Date: August 1, 2003

Subject: Request for additional information (FCC ID: IHDT56CB2)

Application Received:	7/22/2003
Correspondence Reference Number:	230730.IHD
Confirmation Number:	TC3183
Date of Original Email:	7/30/2003

GSM 850 Block A Upper Band Edge

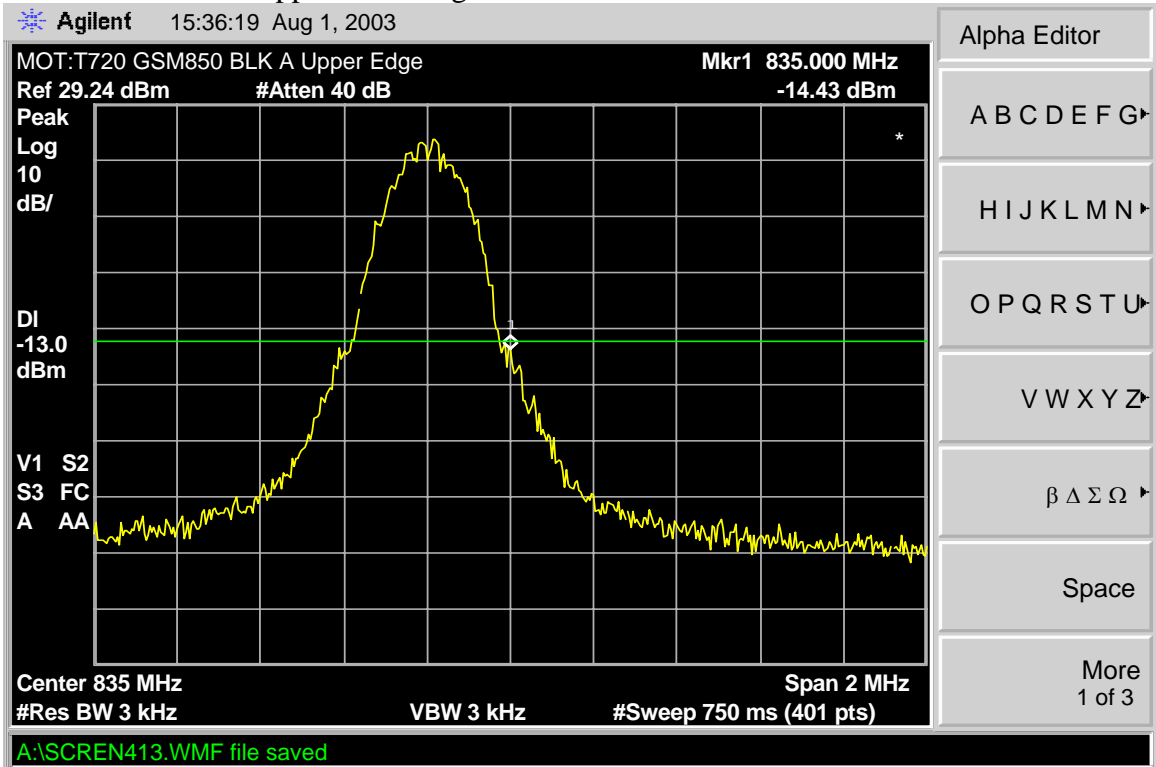
- 1) Please submit the block edge plots for both cellular and PCS frequency bands (see attached).

Response: Please refer to the following plots:
